**Attention: City of Austin Historic Landmark Commissioners  
916 Congress Avenue COA – Changes in permitted set**

### 916 CONGRESS AVENUE

PERMIT SET

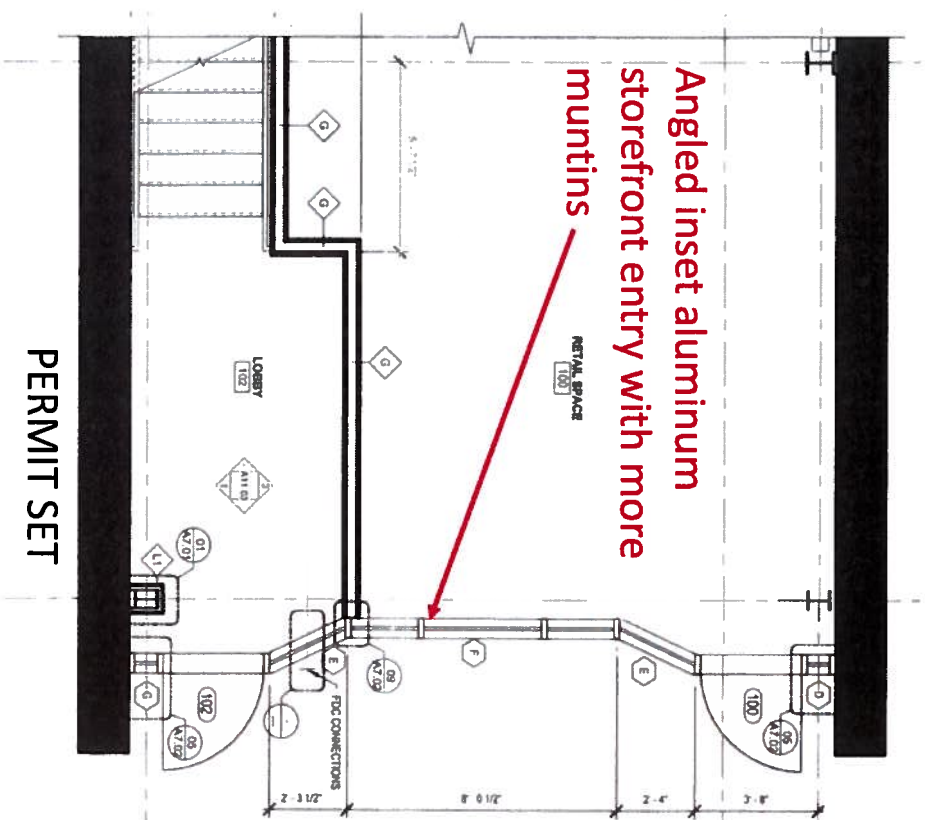
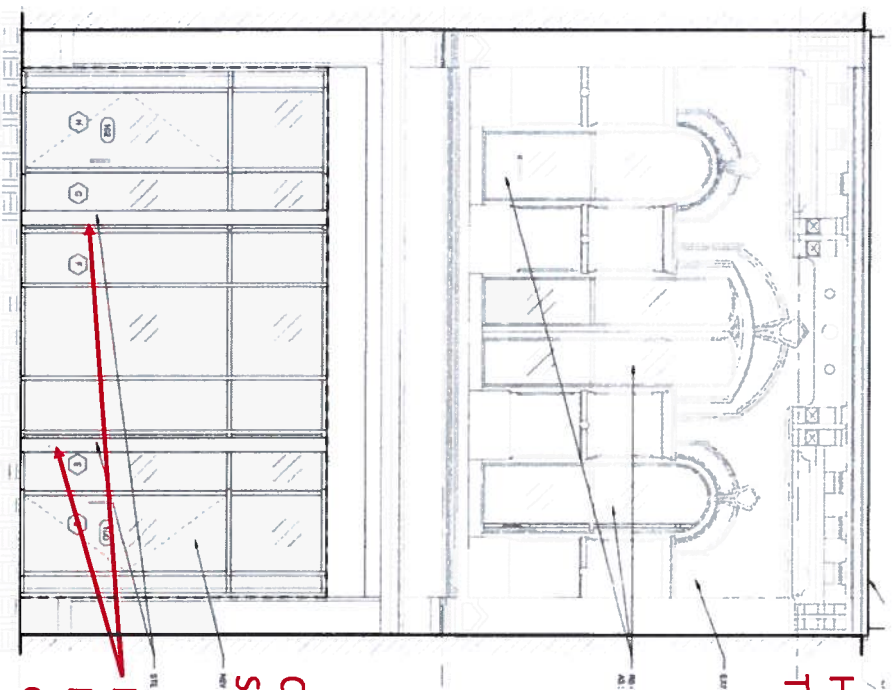
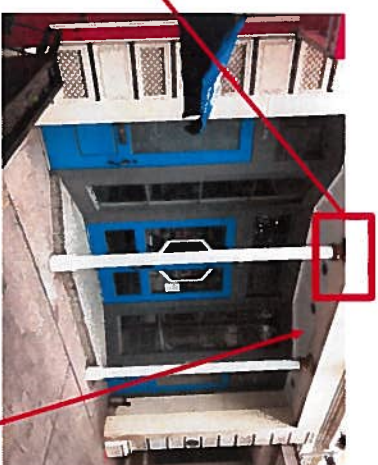
Historic columns  
To be removed

Contemporary Aluminum  
Storefront

Historic columns to be  
Replaced with steel pipe  
columns

Wood beaded board soffit  
to be replaced with stucco

COA APPROVED – FLAT GLASS

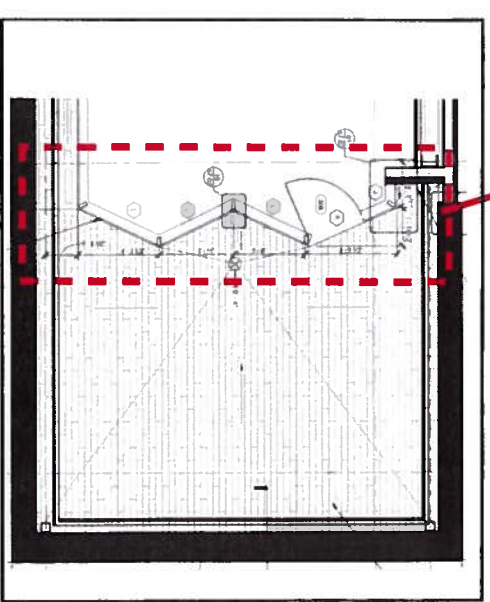
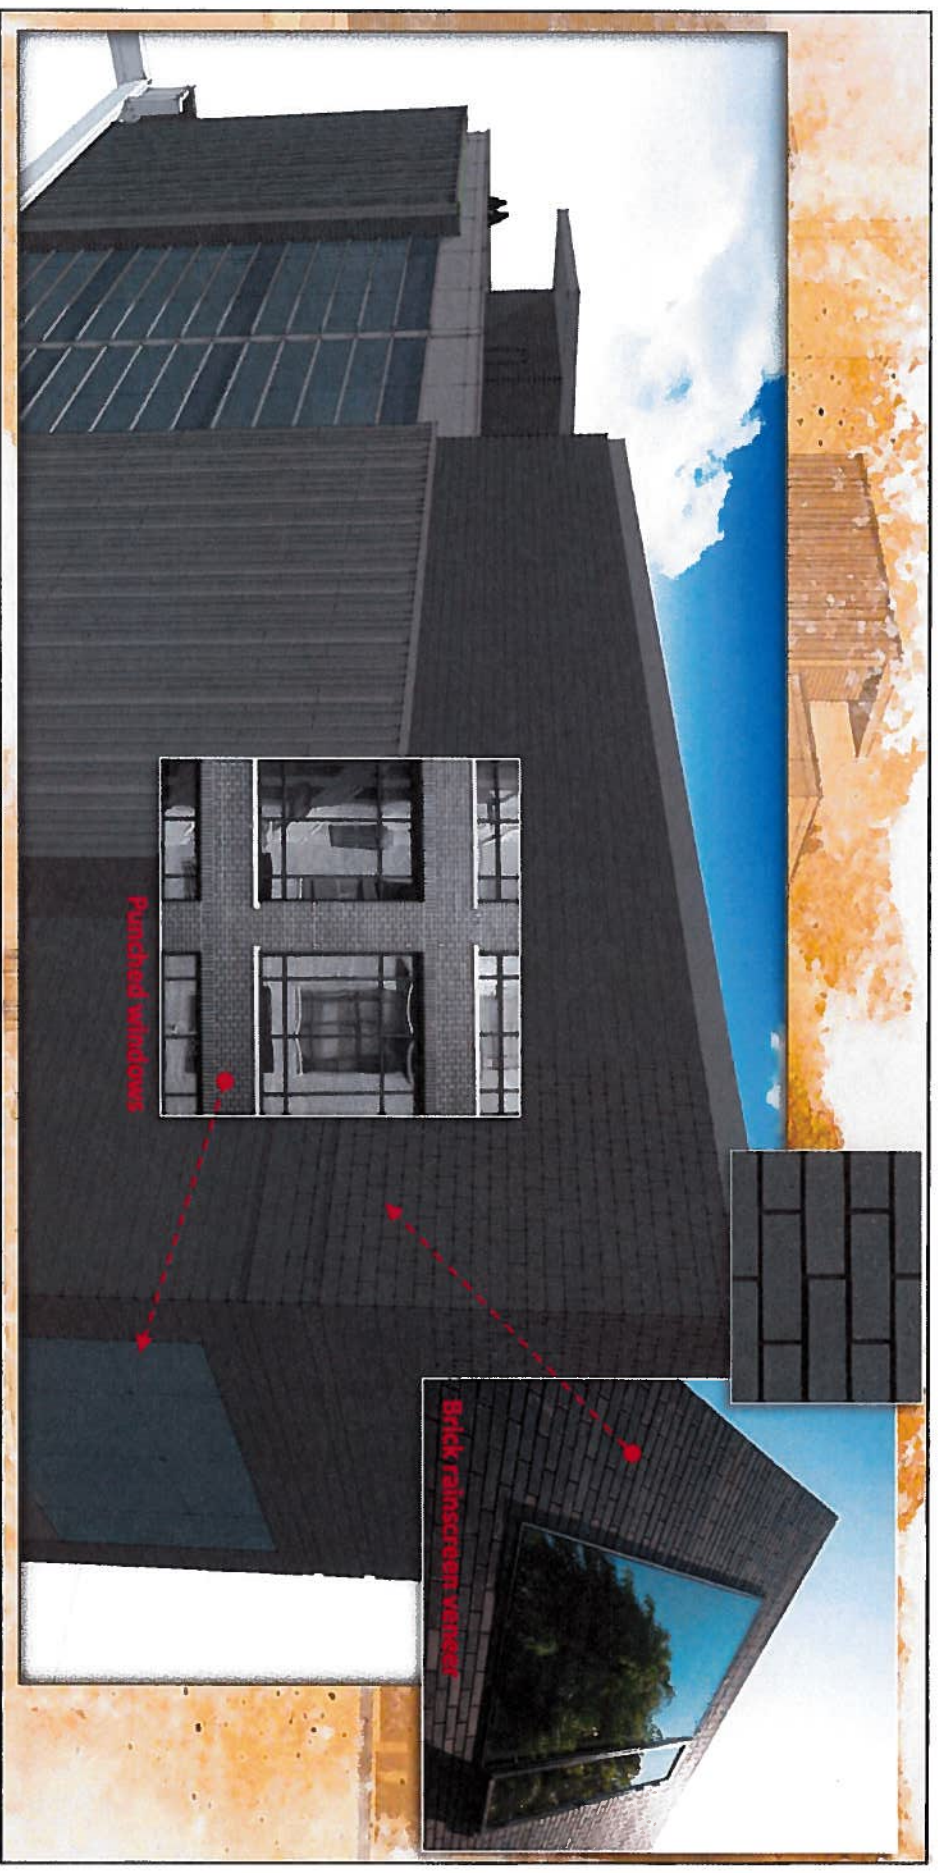
COA APPROVED – FLAT GLASS

PERMIT SET – FACETED GLASS

FACIATED WINDOW WALL

FACIATED WINDOW WALL AT TERRACE WITH GLAZED EXTERIOR DOOR

COA APPROVED – BRICK  
RAINSCREEN VENEER

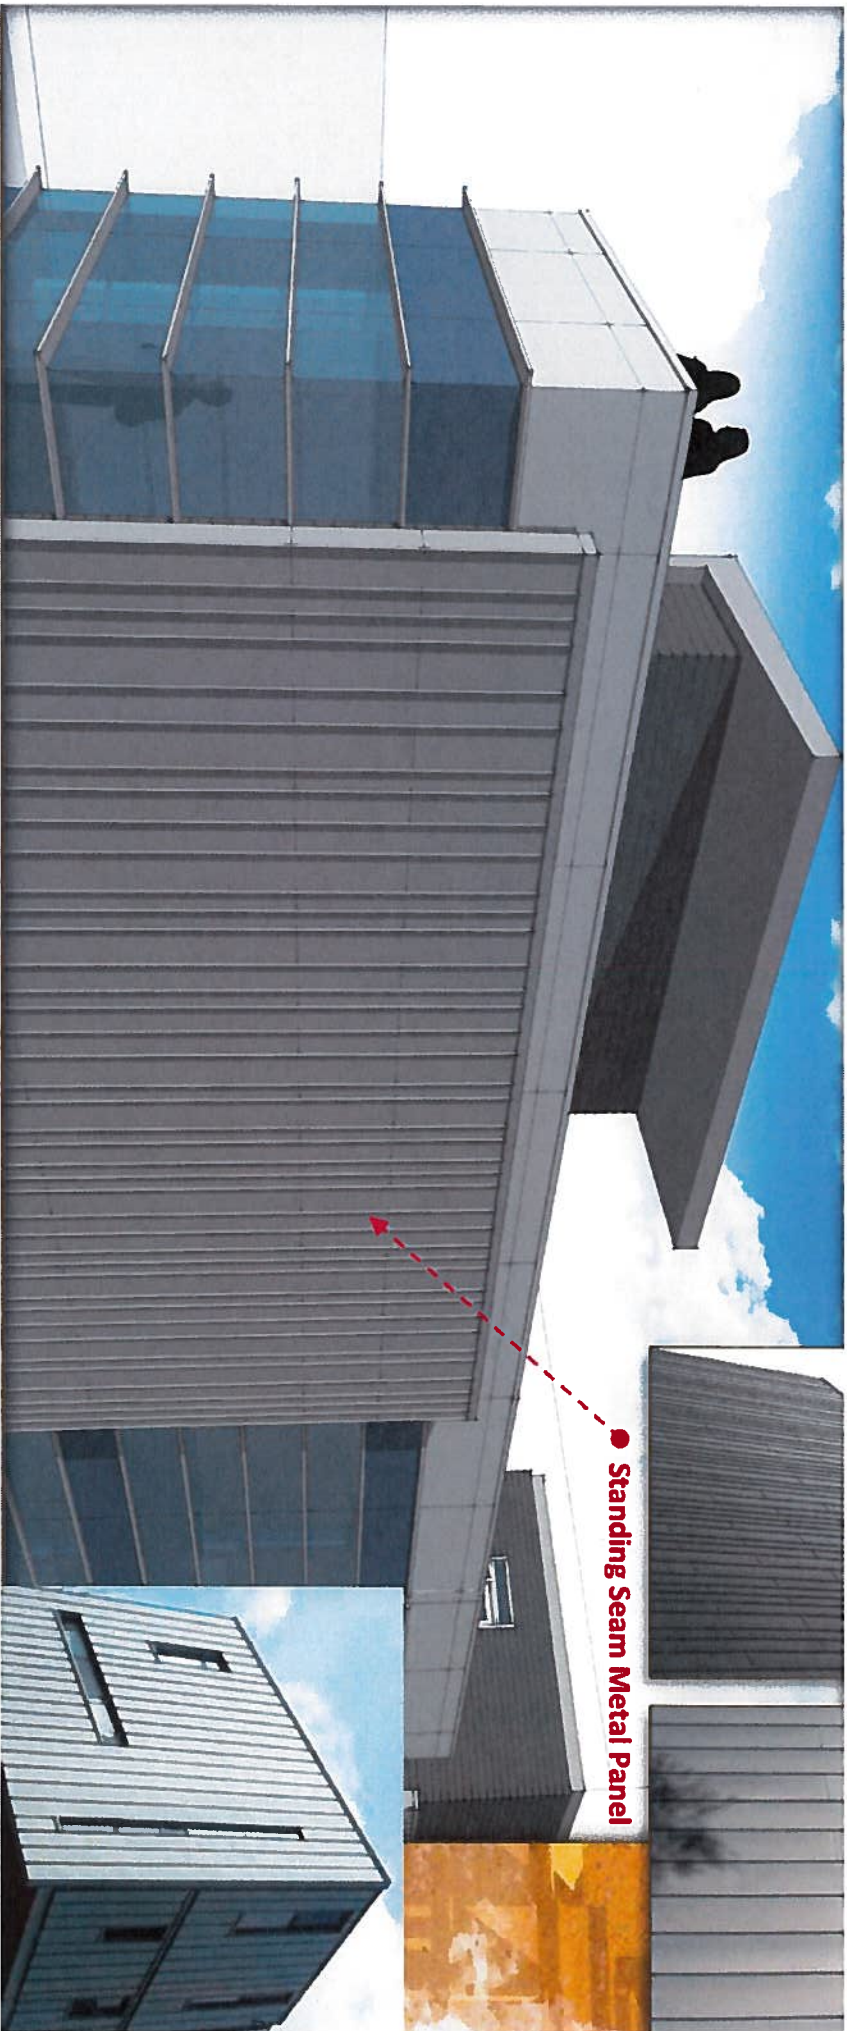
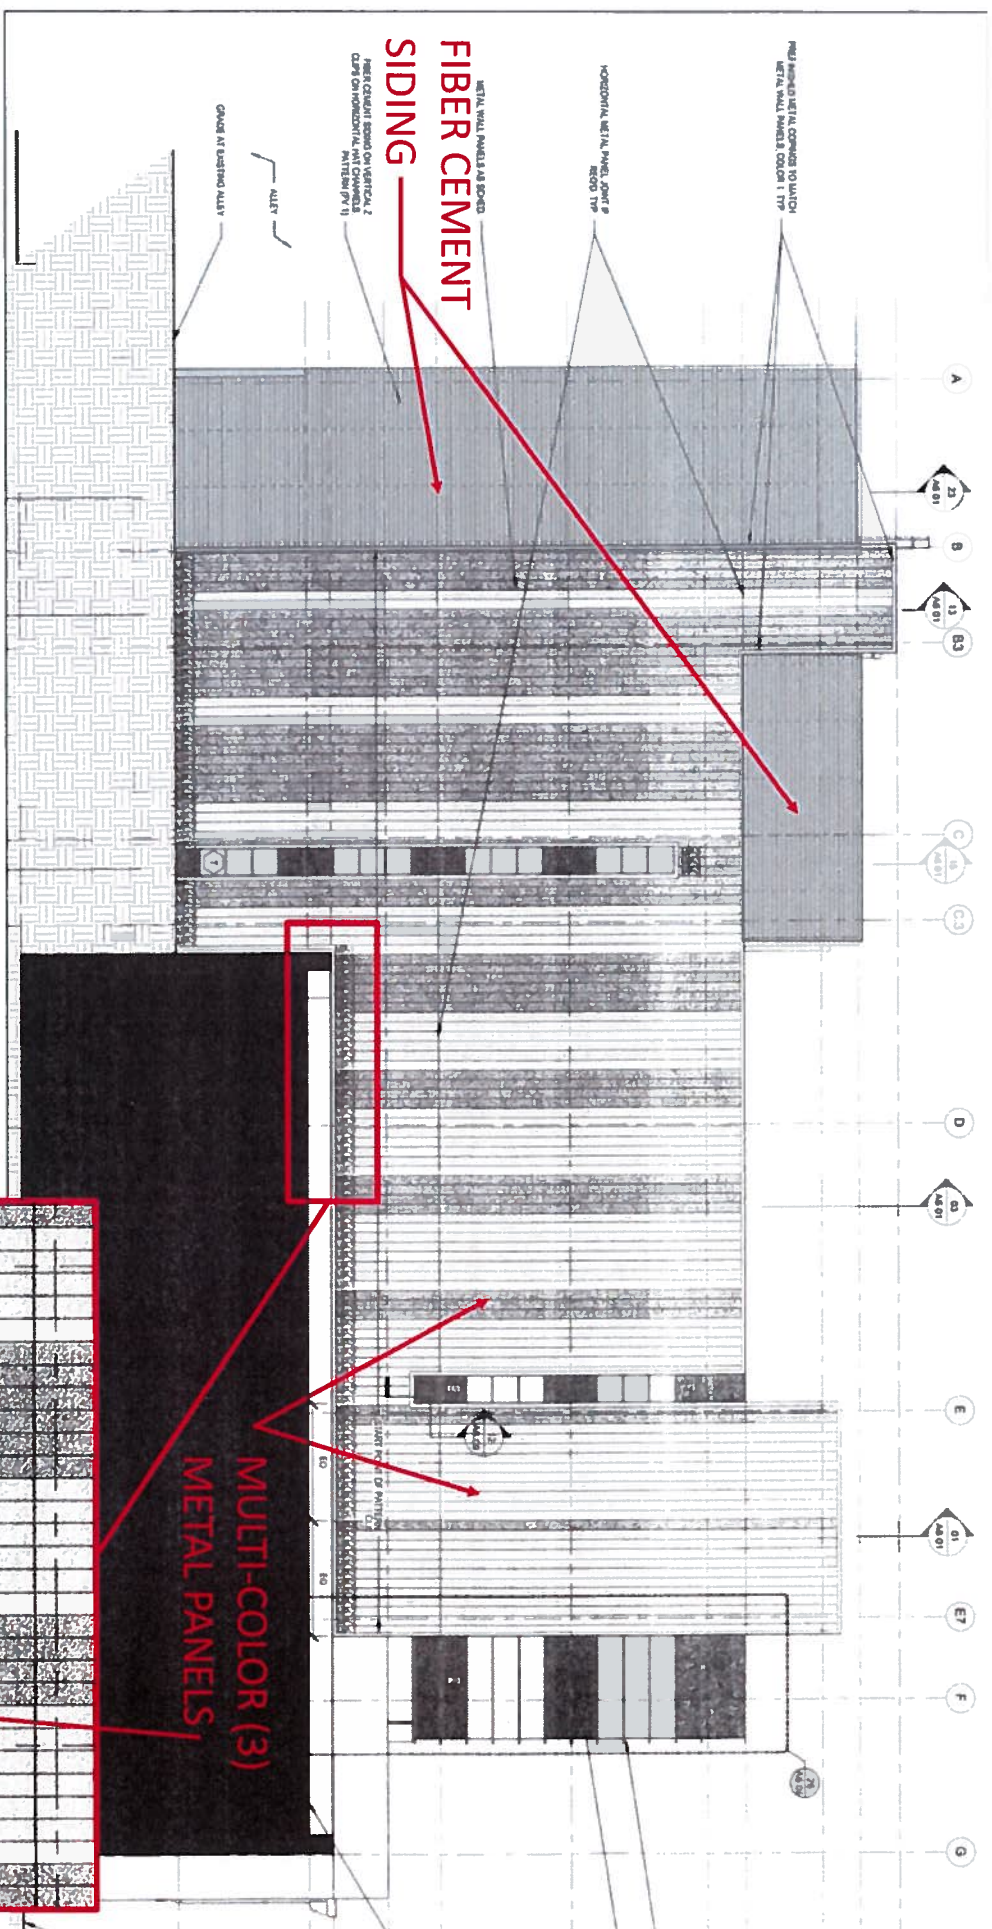
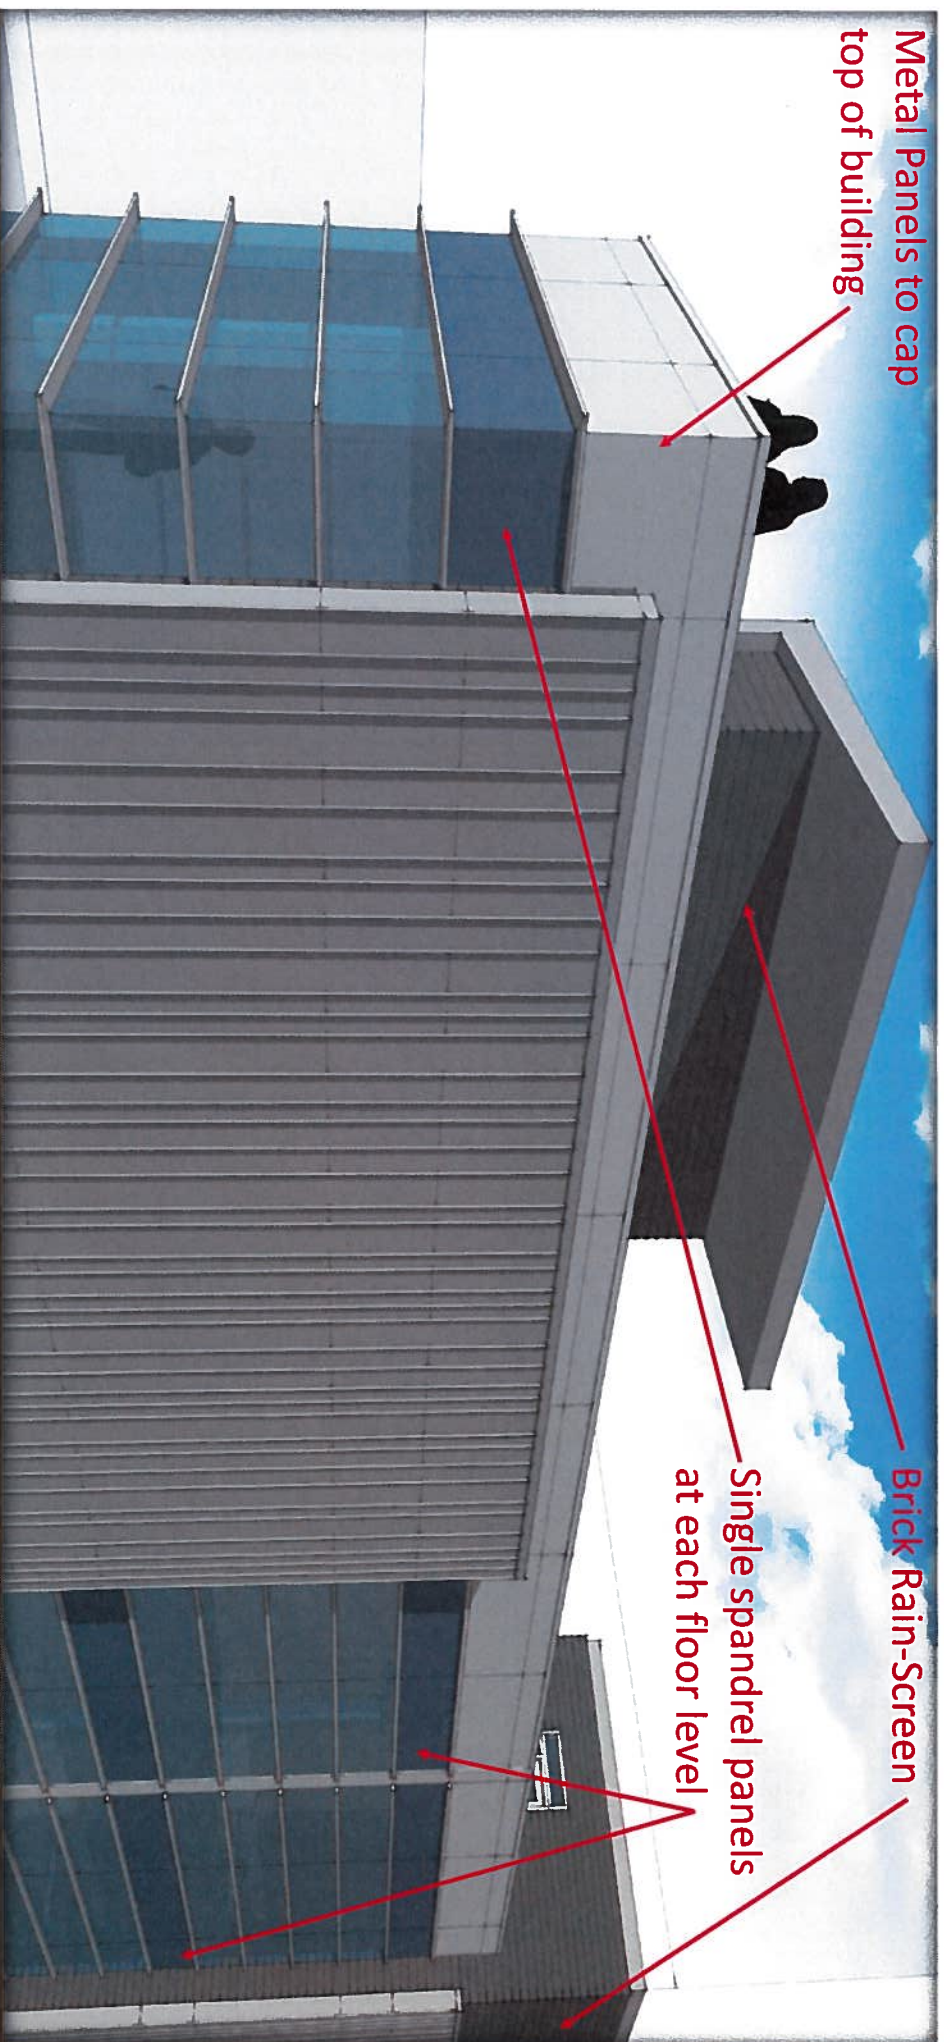
4. Brick Rainscreen: The brick rainscreen material has been changed to fiber cement siding (hardiboard), which is more of a residential material.
5. Vertical Metal Siding: This material has changed from a single color random width standing seam wall panel to regular with multi-colored metal panels.

# PERMIT SET – NORTH ELEVATION

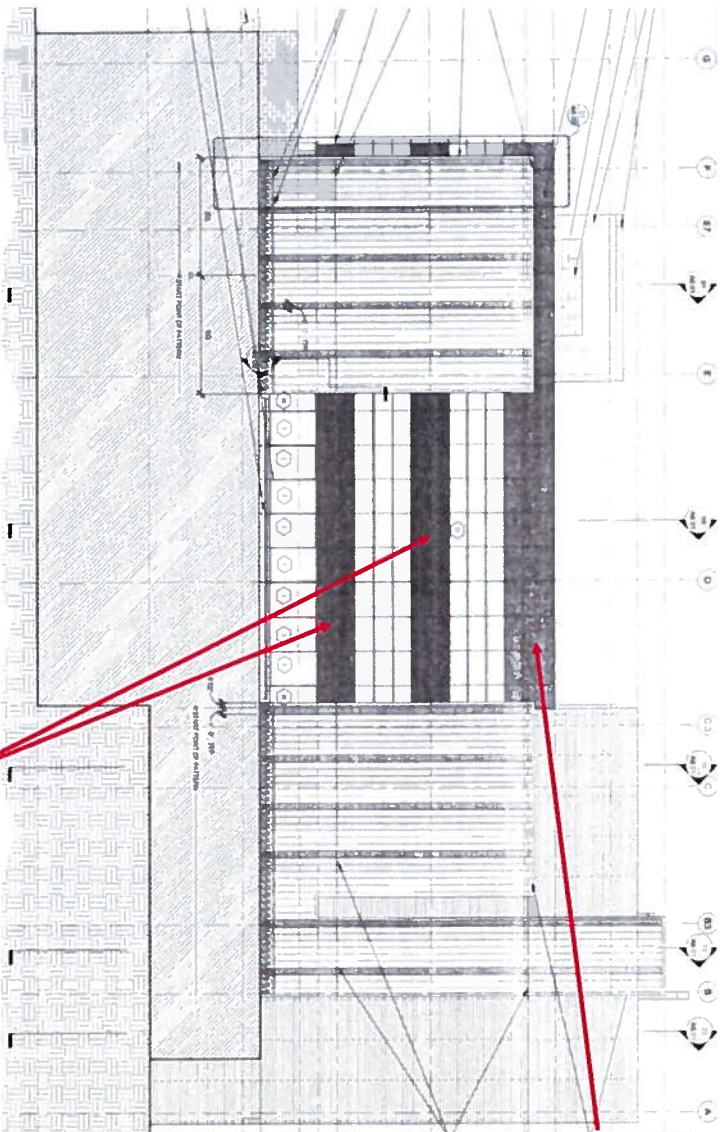
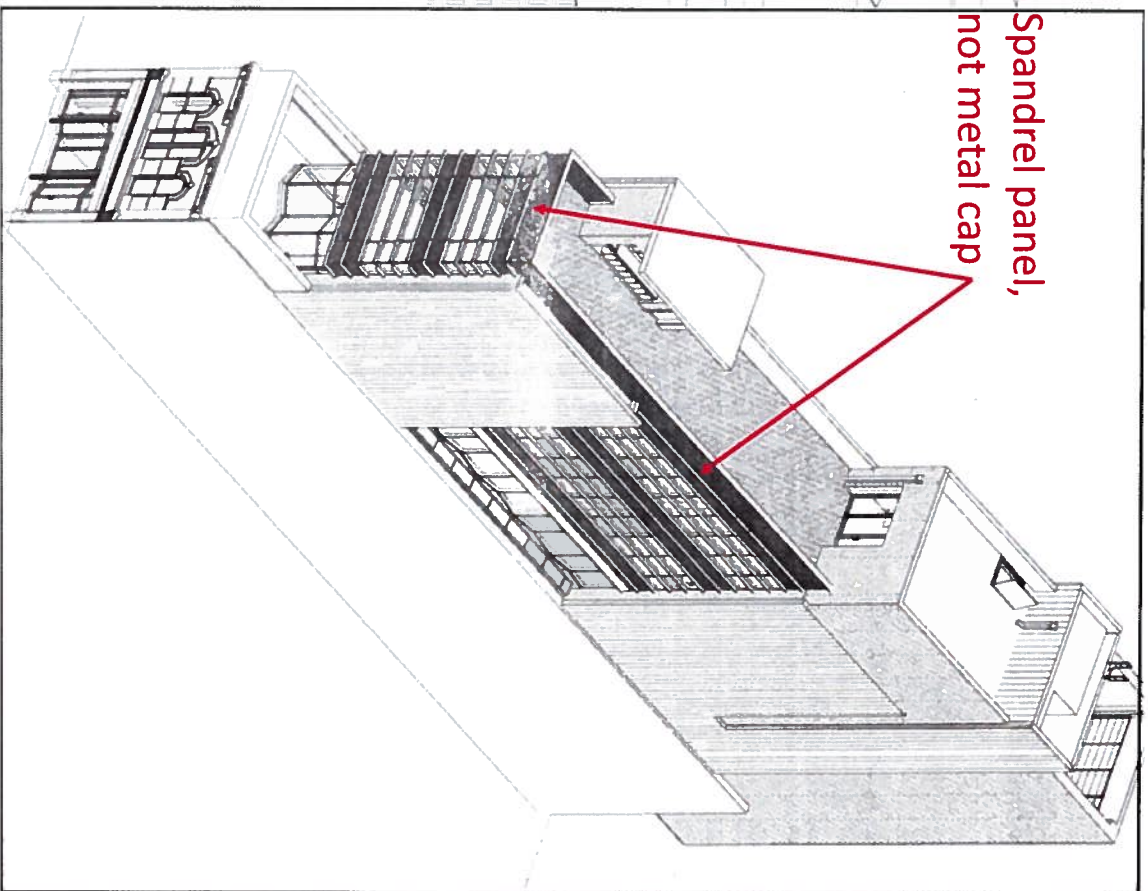
- Metal Panel at top of building
- single spandrel panels at each floor level

Wider multiple  
spandrel panel  
bays
